Access Compliance Report

Public Rights-of-Way

(Curb Ramps)

Intersection ID: 50445	Main Street: ELIZABETH MADISON CT	Cross Street: ALICE MCGINN DR	Location: NW
ADA ID: 3090FD897BFA	Ramp Type: PerpDiag	Initial Pass/Fail: Fail	Overall Compliance: No
Severity Score: 22.5			
Codes/Mitigation Info/Possible Solution		Field Measurements/Component Compliance

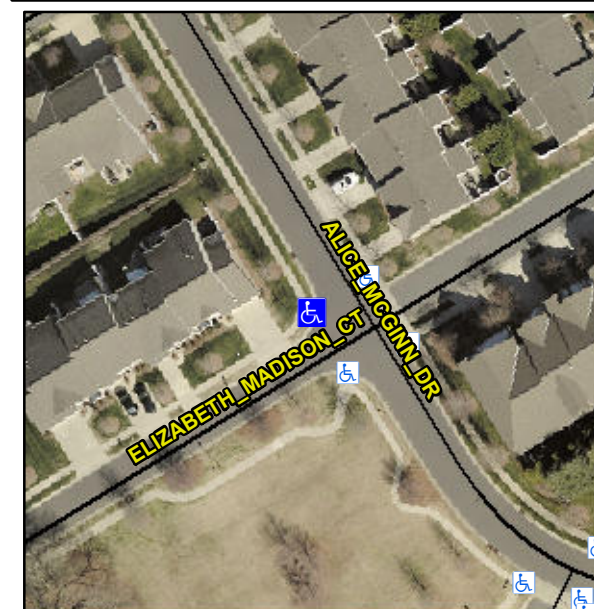
Not Found, R304.5.1, R304.2.2, R304.5.3

Compliance	Description	Data	Compliance	Description	Data
N/A	Ramp Length (in)	46.0	No	Ramp Slope (%)	9.4
No	Ramp Width (in)	46.0	No	Ramp XSlope (%)	3.3
N/A	Flare Type LT	N/A	N/A	Flare Type RT	N/A
N/A	Flare Slope LT (%)	N/A	N/A	Flare Slope RT (%)	N/A
N/A	Flare Traversable LT?	N/A	N/A	Flare Traversable RT?	N/A
N/A	Landing Length (in)	N/A	N/A	DWS Provided?	N/A
N/A	Landing Width (in)	N/A	N/A	DWS Contrast?	N/A
N/A	Landing Slope (%)	N/A	N/A	DWS Length (in)	N/A
N/A	Landing X Slope (%)	N/A	N/A	DWS Full Width?	N/A
N/A	Landing Curb? (Y/N)	N/A	N/A	DWS Offset (in)	N/A
N/A	Shared Landing?	N/A			
N/A	Gutter Ponding?	N/A	N/A	Gutter Slope (%)	N/A
N/A	Gutter Lip Ht (in)	N/A	N/A	Gutter X Slope (%)	N/A
N/A	Painted X Walk1?	No	N/A	Painted X Walk2?	No
	X Walk 1 Direction	To SE		X Walk 2 Direction	To NE
N/A	X Walk 1 Width (in)	N/A	N/A	X Walk 2 Width (in)	N/A
	X Walk 1 Slope (%)	3.3		X Walk 2 Slope (%)	0.4
	X Walk 1 X Slope (%)	0.5		X Walk 2 X Slope (%)	3.2

Remove & Replace Curb Ramp With Two New Directional Ramps or Equivalent.
